UNITED STATES PATENT AND TRADEMARK OFFICE

APPLICATION NO.	FILING DATE	FIRST NAMED INVENTOR	ATTORNEY DOCKET NO.	CONFIRMATION NO.
09/804,792	03/14/2001	Poramaste Jinupun		2022

Office Action Summary

DETAILED ACTION

(A) Core with salient pole, each pole have teeth and windings.

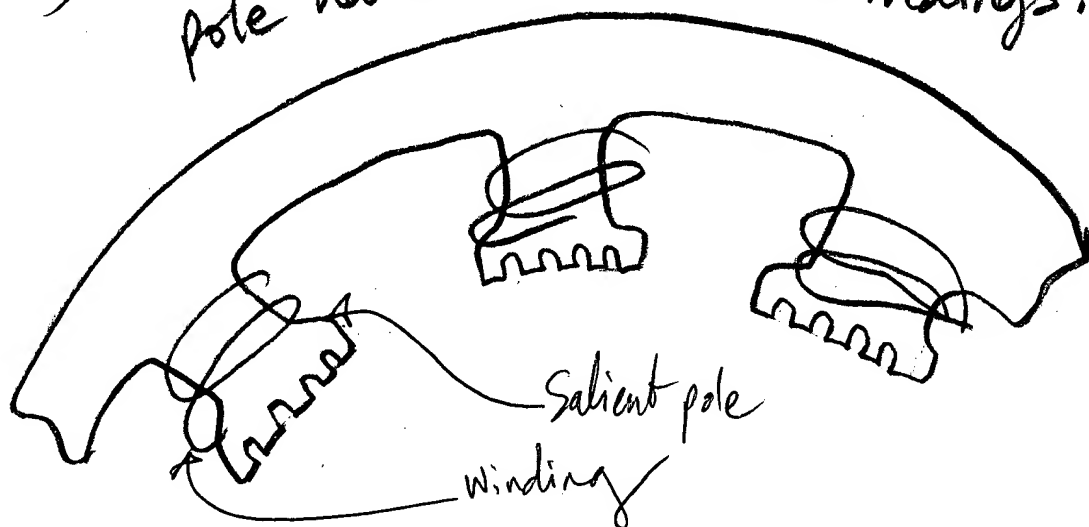
The drawings are objected to under 37 CFR 1.83(a). The drawings must show every feature of the invention specified in the claims. Therefore, *the salient poles of first assembly, wherein each pole subdivided into plural teeth, the windings wound one each or on alternate ones of respective teeth*, as in claim 1 lines 1-5 must be shown or the feature(s) canceled from the claim(s). No new matter should be entered. Note: Fig. 11d-22 show stator with plural poles, not each pole has plural teeth (see attachment).

The drawings of the claimed invention do not clearly distinguish whether the claimed invention is case (A) or (b).
